Holt Hill – 19169

Site visit 28.01.2021

SITE VISIT 28.01.2021
1:100

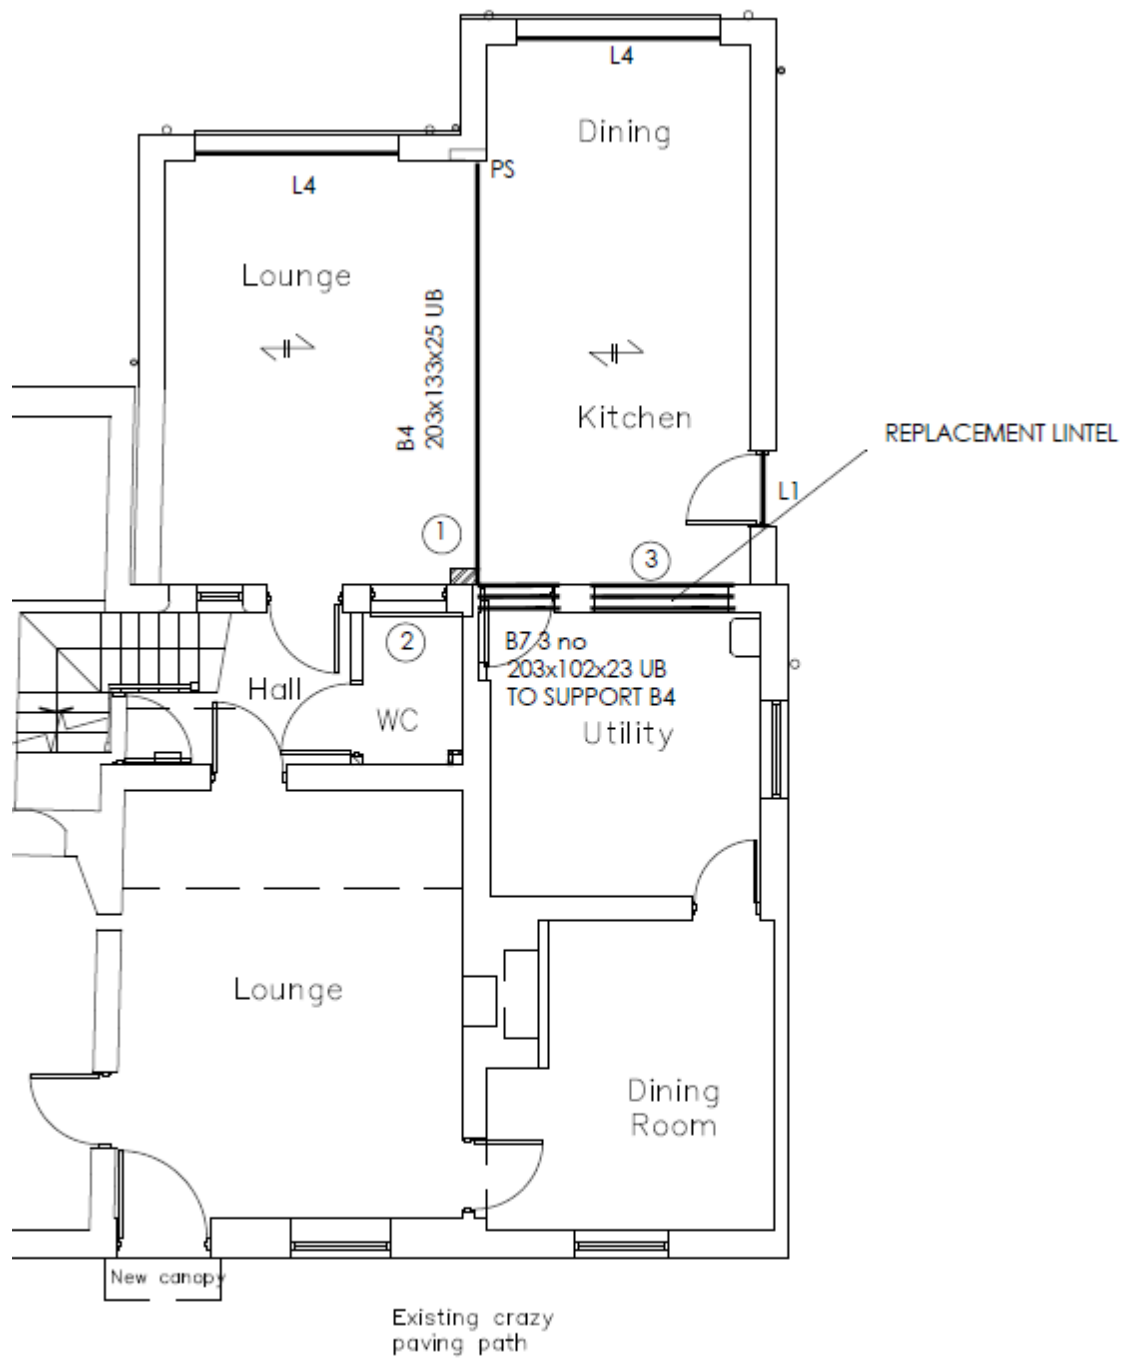
1 – existing masonry pillar fixed to face of house wall has no support therefore cut back brickwork flush with adjacent house face.

2 – existing doorway to be infilled, provide new 400x225 GEN1 concrete footing and extend this sufficiently to underpin the pier between the two openings. Infill to be 3.5N solid block in class ii mortar tied in to existing masonry on both sides.

3 – existing timber lintel is rotted and no longer serviceable, replace with 3 number 152x89x16 UB bolted together (wall thickness may require 4 beams)

B7 – make B7 same depth as B4 for practical connection detail, note multiple are required due to wall thickness.

CONNECTION
DETAIL B4 TO B7

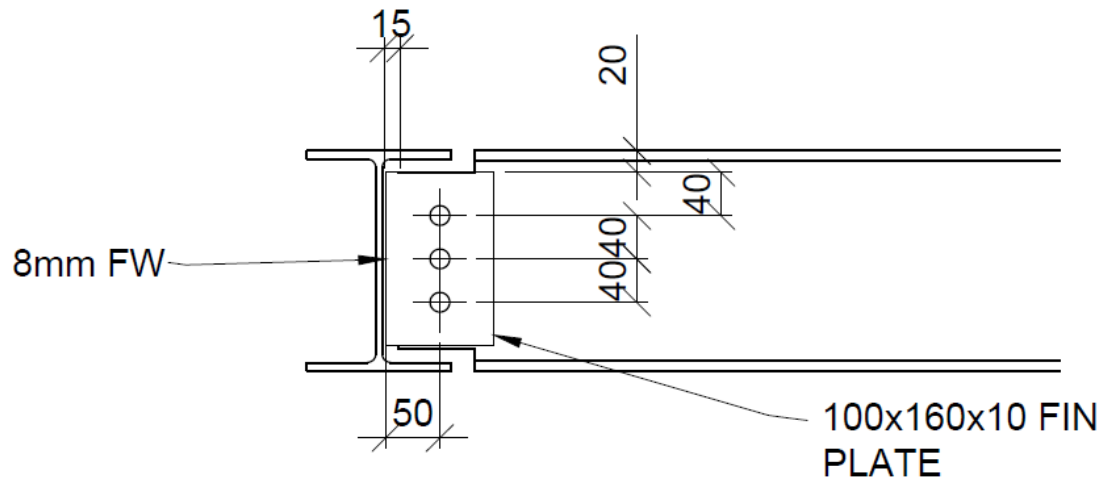
M16 GRADE 8.8 BOLTS IN STANDARD HOLES, 8mm FW, INCOMING BEAM TO HAVE 70x20 NOTCHES.
